UNITED STATES PATENT AND TRADEMARK OFFICE

10/571,065

Office Action Summary	Application No. 10/571,065	Applicant(s) ONDA ET AL.	
	Examiner ERIKA VILLALUNA	Art Unit 2852

DETAILED ACTION

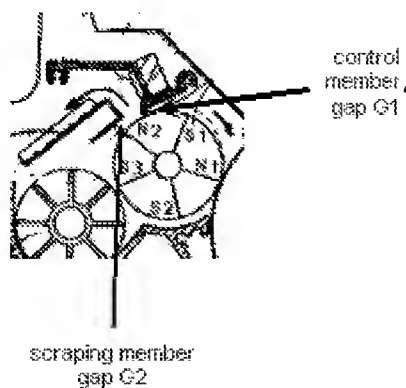
Regarding claims 17-20, Endo discloses a scraping member (bottom right corner portion of plate 26) physically attached to said reflux plate (26) at a vicinity of said reflux plate disposed of an outer periphery of said developing roller (26 is disposed at an outer periphery of developing roller 23), wherein said scraping member faces said developing member (bottom right corner portion of plate 26 faces developing roller 23) wherein said scraping member is integrally formed with said reflux plate (bottom right corner portion of plate 26 is integrally formed with plate 26); wherein a gap (G2) exists between said scraping member and said developing roller (a gap exists between bottom right corner portion of plate 26 and developing roller 23); wherein the gap G2 is a second gap, wherein a first gap (G1) exists between said control member (24) and said developing roller, and wherein a relationship $G1 < G2$ holds true (gap between bottom right corner portion of plate 26 and developing roller 23 is larger than a gap between regulating board 24 and developing roller 23). See annotated figure below.
